Important Notices

TOSHIBA Microcontrollers TLCS-870 Family
TLCS-870/C1 Series

Restrictions on the Voltage Detection Circuit

Datasheet Corrections: Electrical Characteristics of the Power-On Reset Circuit

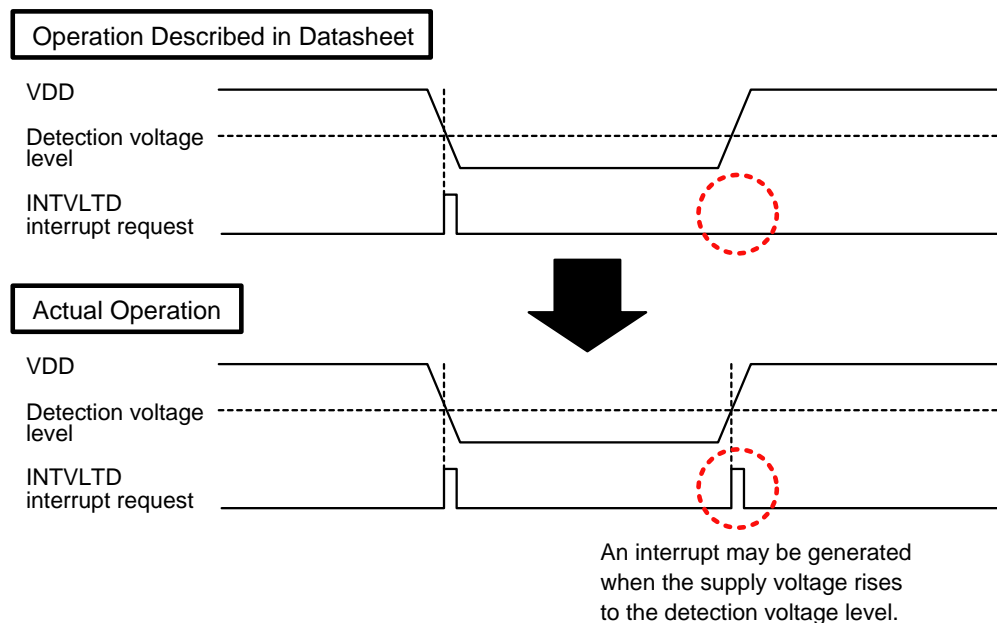
This is to inform you of restrictions on the voltage detection circuit in the TLCS-870/C1 Series of microcontrollers.

When interrupt generation is enabled in the voltage detection circuit, an INTVLTD interrupt request may be generated not only when the supply voltage falls to the detection voltage level, but also when it rises to the detection voltage level.

In ICE mode of the In-Circuit Emulator (TMP89C900), no interrupt request is generated when the supply voltage rises to the detection voltage level. Therefore, with products supporting the In-Circuit Emulator (TMP89C900), the interrupt generation operation may differ between the development tool and the actual product.

The SRSS bit in the voltage detection control register 2 (VDCR2) provided for releasing STOP mode by voltage detection cannot be used because it does not function as expected.

Do not use the INTVLTD interrupt for voltage detection. The voltage level should be regularly checked using other timing such as the execution cycle of the main program. VDCR1<VDxSF> (x=1, 2) can be used to check the voltage level. However, if the operating voltage is near the detection voltage, the VDCR1<VDxSF> value may become unstable. It is recommended that VDCR1<VDxSF> be tested multiple times to determine the voltage level.

Always set VDCR2<SRSS> to "00". Use the STOP pin to release STOP mode.
